Proposed 132kV transmission line, Manjimup to Beenup mineral sands mine

State Energy Commission of Western Australia

**Report and recommendations
of the Environmental Protection Authority**

**Environmental Protection Authority
Perth, Western Australia
Bulletin 707
October 1993**

Figure 1. Study area showing areas with national estate values. Source: CER — Dames & Moore

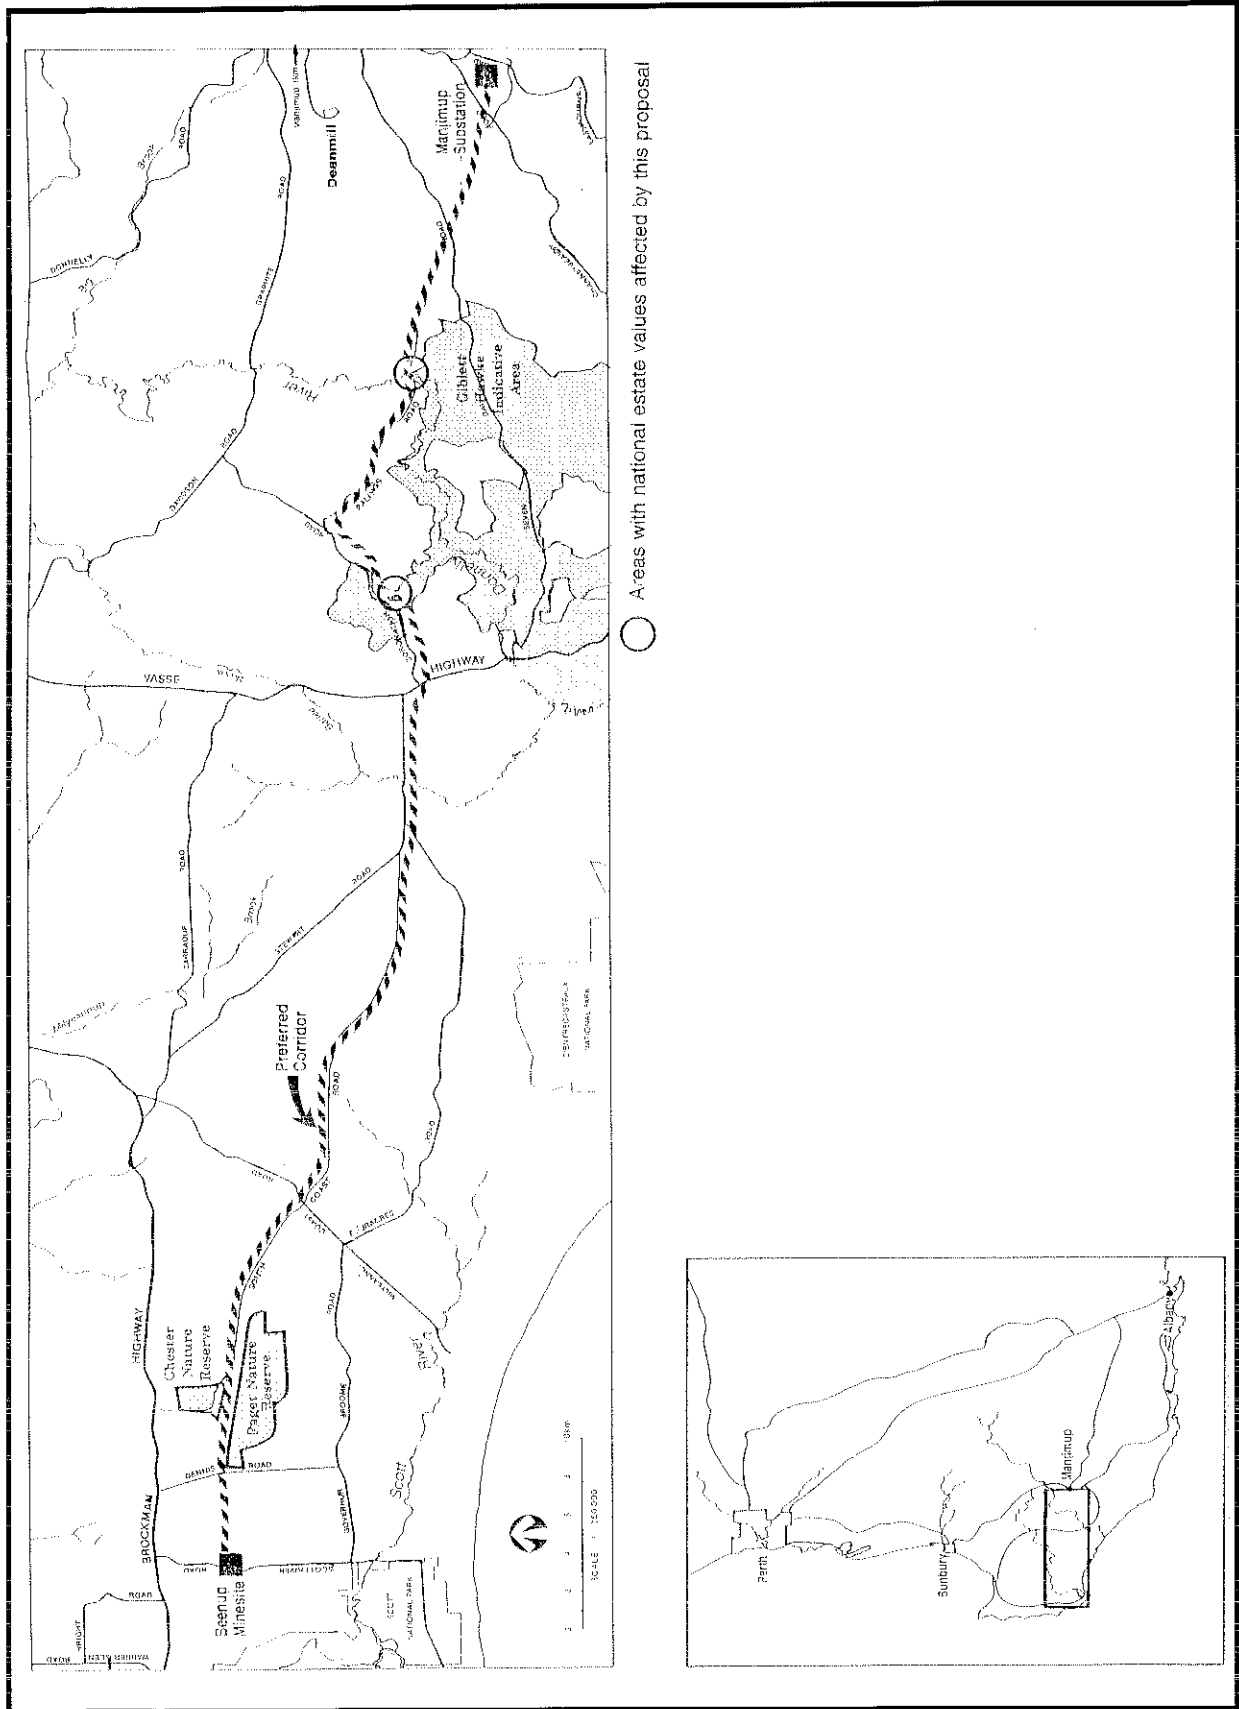
The area to the south of the Donnelly River crossing at Palings Bridge (figure 1) is listed on the Interim List of the Register of the National Estate. Because of this the proponent was proposing to place the line on the north side of Palings Bridge. However, there is an existing cleared swathe on the south side of the bridge. It would be environmentally preferable to take advantage of this clearing when constructing the line to minimise clearing of forest with national estate values.

Adjacent to Coronation Road the transmission line traverses approximately 1.5km of an area on the Interim List of the Register of the National Estate (figure 1). Normally the Authority would prefer infrastructure such as roads and powerlines to be kept in the same easement to prevent additional disturbance to the environment. However, in this case, the Authority in keeping with its principle of minimising clearing believes the alignment should not be along along Coronation Road but considers the corridor should be as proposed provided the alignment is inside the clearfelled section of this route.

The transmission line affects two areas proposed for listing on the Interim list of the Register of the National Estate. These are the forest on the south side of Palings Bridge at the Donnelly River crossing, and a neck of forest running between Iffley and Gray Forest Blocks on Coronation Road approximately 5km north east of the Coronation Road/Vasse Highway intersection (figure 1).

In the first area, the State Energy Commission planned to put the line on the north side of Palings Road at Palings Bridge to minimise impacts on the area with National Estate values. However, there is an existing cleared area on the south side of the bridge. The Authority considers it would be appropriate to utilise this clearing for the transmission line.

The Environmental Protection Authority recommends that at the crossing of the Donnelly River the line be placed to take maximum advantage of the existing cleared area on the southern side of Palings Bridge.

The Environmental Protection Authority recommends that where the transmission line crosses the area proposed for listing on the Interim List of the Register of the National Estate in Gray Forest Block it:

- a) is located within the 1984 clearfelled area where possible; and**
- b) is located along the forest track in the uncut area such that clearing of older large Karri trees is minimised in consultation with the Department of Conservation and Land Management.**

Figure 2. Proposed clearing profiles. Source. CER — Dames and Moore

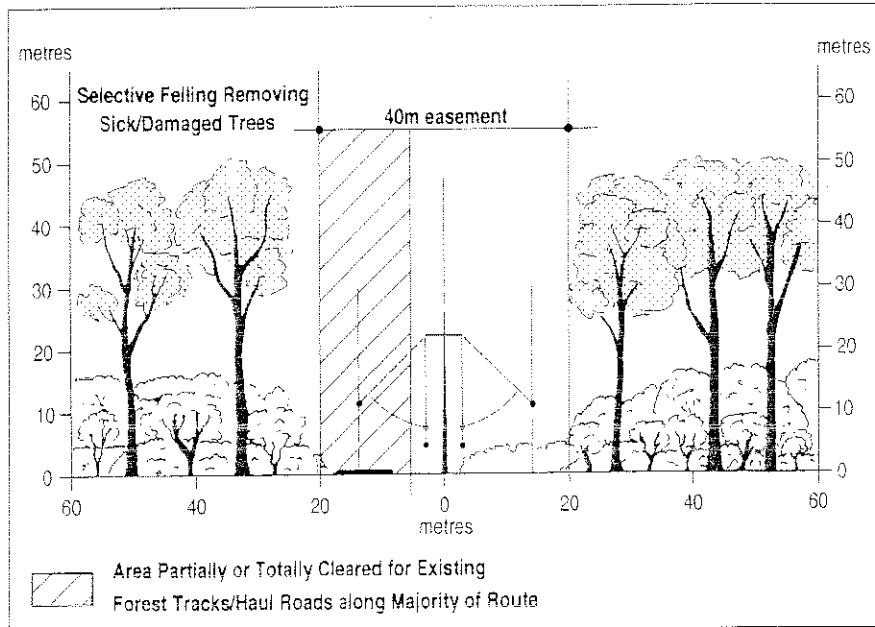
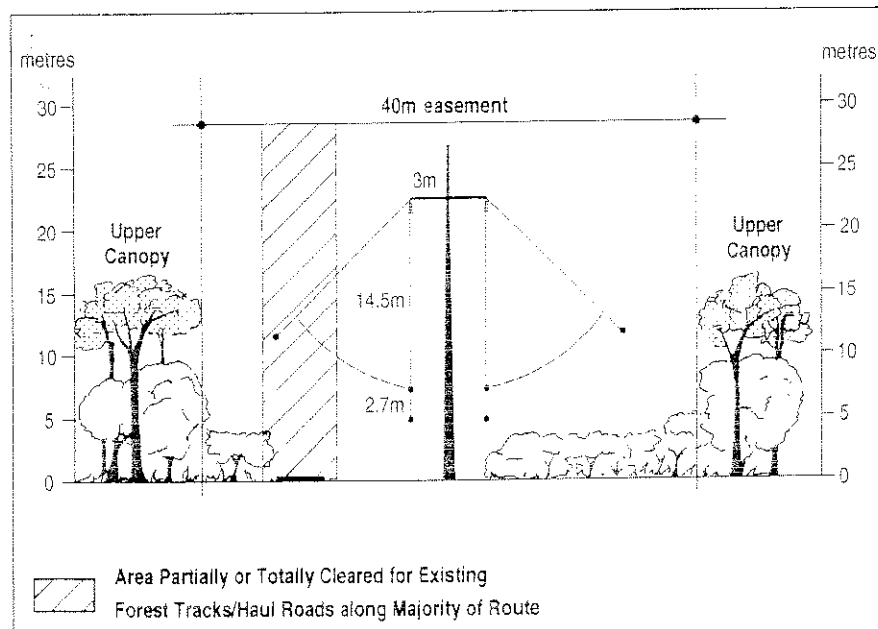
Issue: 25 *Figure 9 indicates that SECWA will require a 120m wide management zone in forest >20m in height.*

Issue: 28 *Figure 9 shows a 6m wide vegetation free area underneath the line but the CER does not detail whether this area will be maintained by mechanical means or the use of chemicals.*

Issue: 11 Figure 9 indicates that a 120m wide management zone is required for forest >20m in height.

Issue: 12 Figure 9 shows a vegetation free zone approximately 6 metres wide under the line. This area is a potential source of erosion and there is no indication as to how this area is to be maintained.

Response: The dimensions shown on the bottom of the Darling Plateau indicate the scale of the sketch, they do not nominate a management zone as suggested above.

Response: Figure 9 gives a schematic representation of the appearance of the easement it is not intended to be an absolutely accurate reflection of the final appearance of the area.

Response: The dimensions shown on Figure 9 on the clearing profile diagram for the Darling Plateau are intended only to provide scope to the drawing. They do not indicate a required management zone.

Response: Figure 9 is intended as a schematic representation of the proposed clearing profile and not an accurate drawing of the final appearance of the easement area.
